FINAL PLAT **SWBC Rockwall Addition, Phase 1** Lots 1, Block A 21.280 Acres

AGENDA ITEM: P2018-033; Final Plat: SWBC Rockwall Addition, Phase 1

Project Number P2018-033

Project Name Lot 1, Block A, SWBC Rockwall Addition,

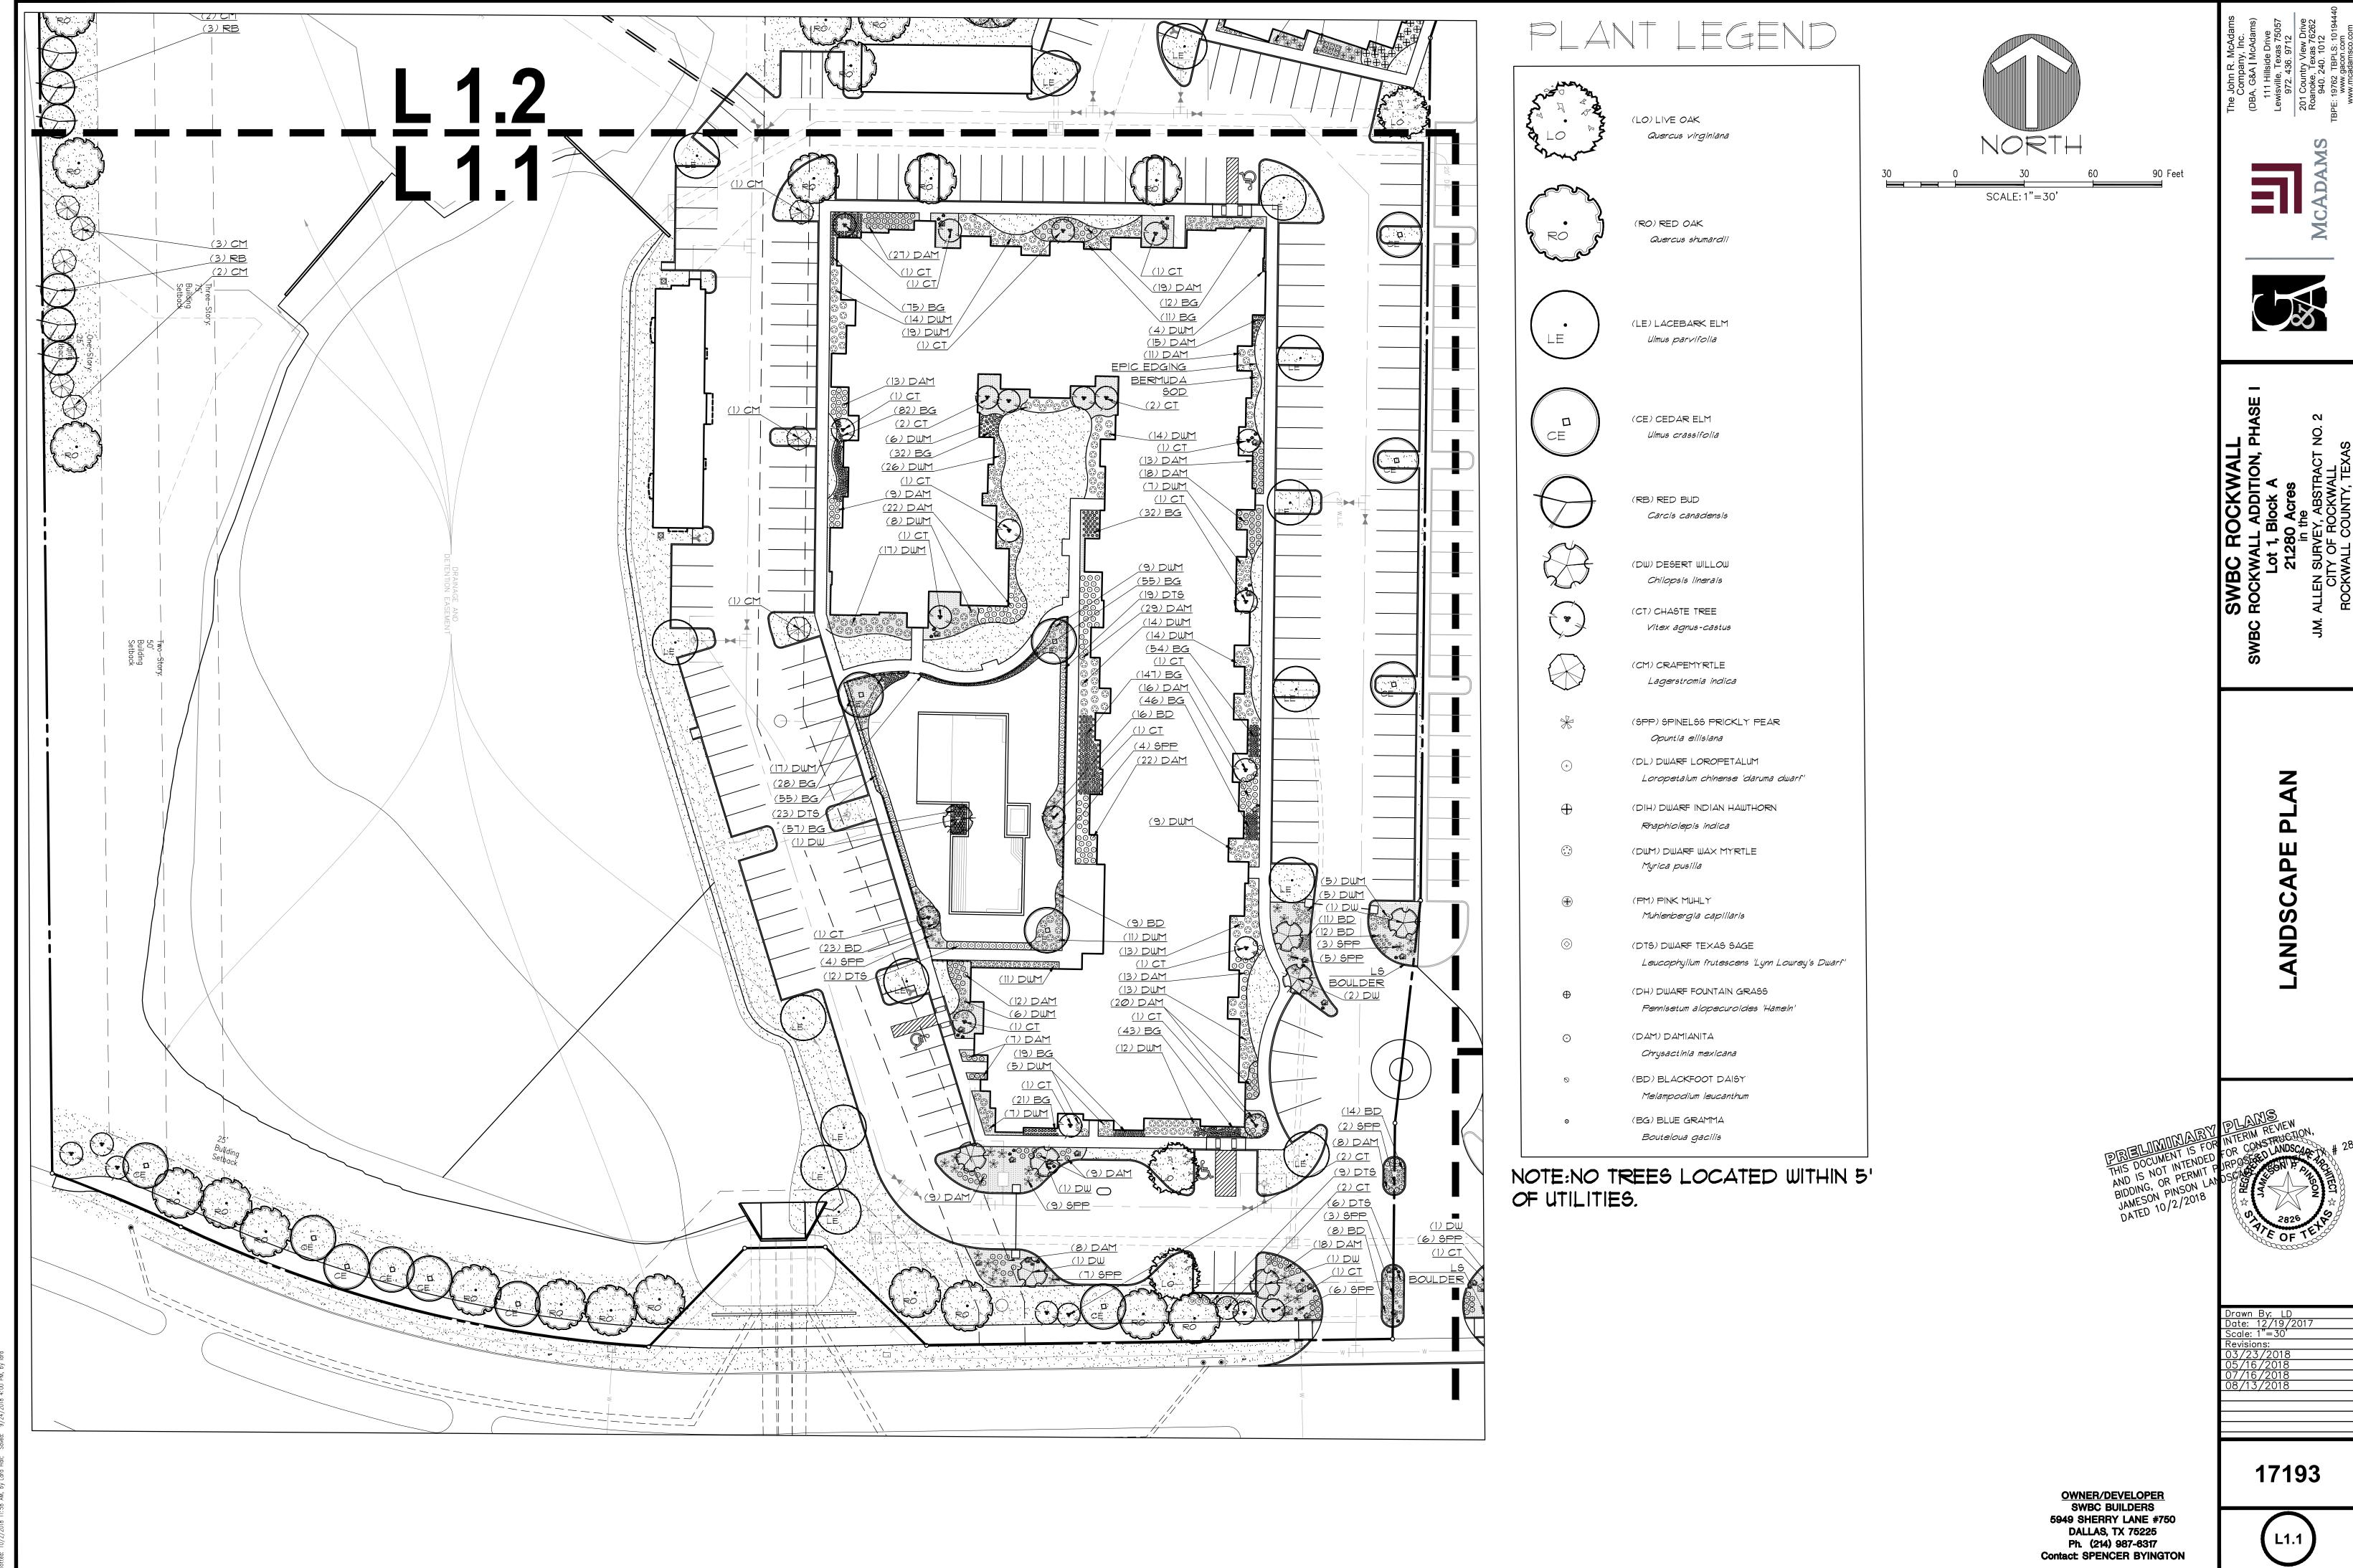
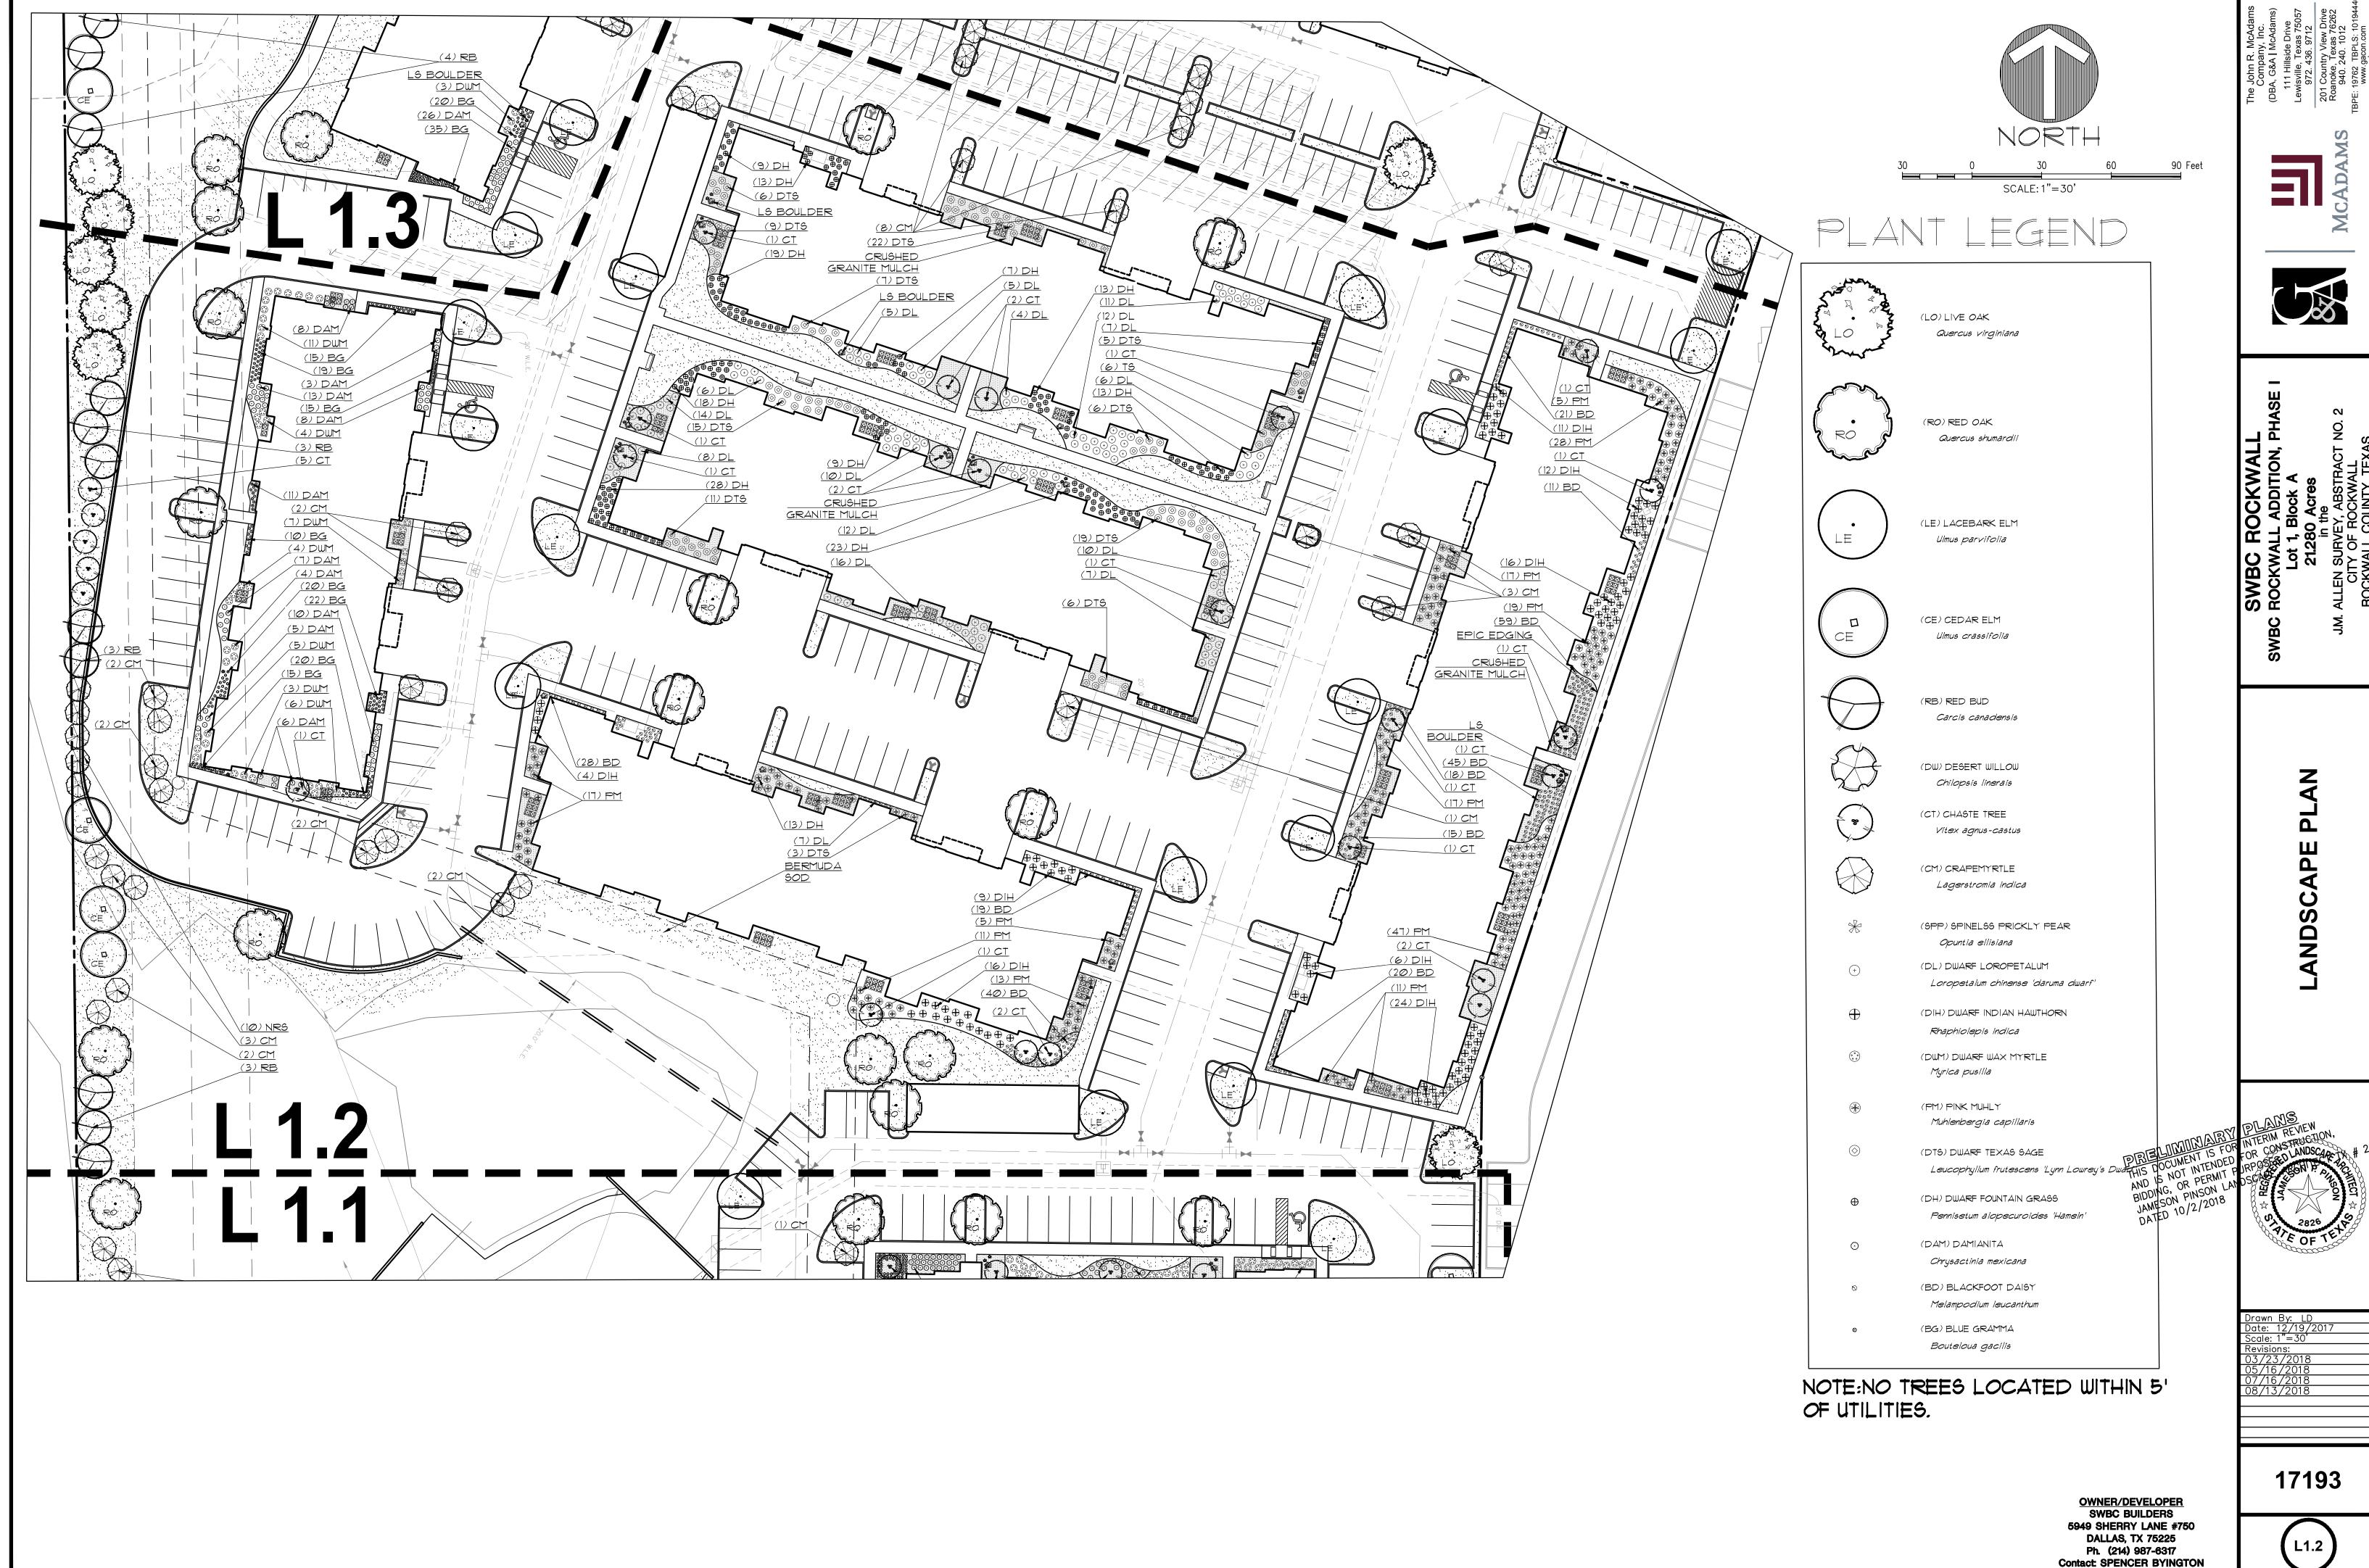
- Add note: No trees within 5' of public utilities.
- Many trees were marked up for being too close to the utilities.

LANDSCAPE TREES SHALL NOT BE PLANTED WITHIN 5' OF ANY PUBLIC UTILITIES.
